Liberty Utilities (Peach State Natural Gas) Corp.
Georgia Public Service Commission
Docket No. DN 42959
Staff's Twenty-Ninth Set of Data Requests

STF-29-1

Table B- GRAM 2026 filing

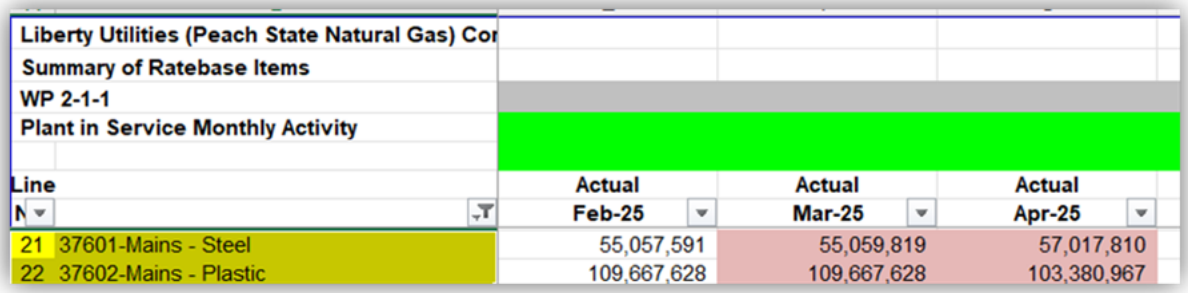
c. Please explain why the GRAM filing has a different FERC account number than the Q2 filing. Please see Table A and Table B.

c. The difference in the account number presentation between the Annual GRAM filing and the Q2 filing is attributable solely to variations in abbreviation and formatting conventions. Both filings reference the same underlying FERC account.

Table B – Required and Alternative 2026 GRAM

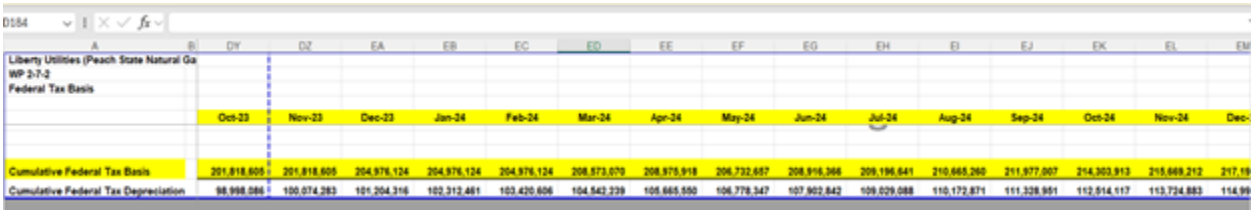
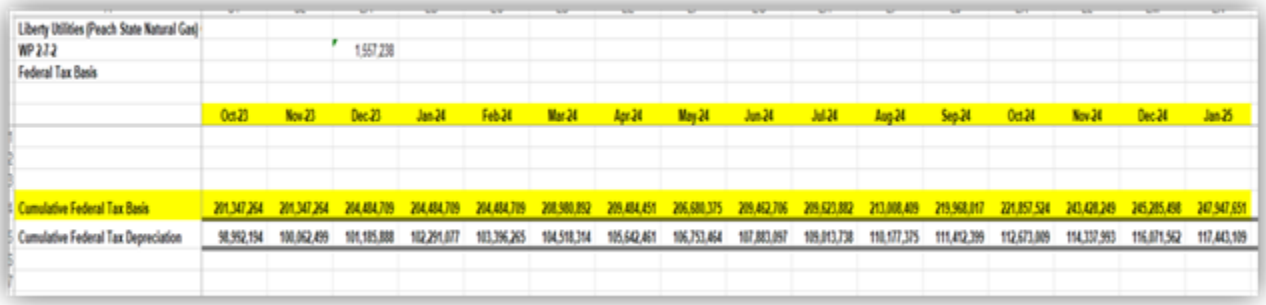
a. Please explain why there is a variance in the tax basis from what was approved in the 2025 Revised GRAM.

b. Additionally, it also shows variance from October 2023 to January 2025 in both GRAM filing. Please explain why there is a variance in the tax basis when it is approved in 2024 and 2025 GRAM.

a. The difference is caused when we update our forecasted balance to actual balance. The cumulative federal tax basis reflected in December 2024- GRAM 2026 filing and the tax basis approved in the 2025 Revised GRAM arises from the distinction between the forecasted and actual plant in-service additions. The 2025 Revised GRAM Incorporated tax basis values derived from forecasted plant additions, which were reasonable at the time of approval but inherently subject to change. The GRAM 2026 filing, by contrast,

reflects actual plant in service additions that occurred during the period. As a result, the cumulative federal tax basis has been updated to align actual balances rather than the previously forecasted amounts.
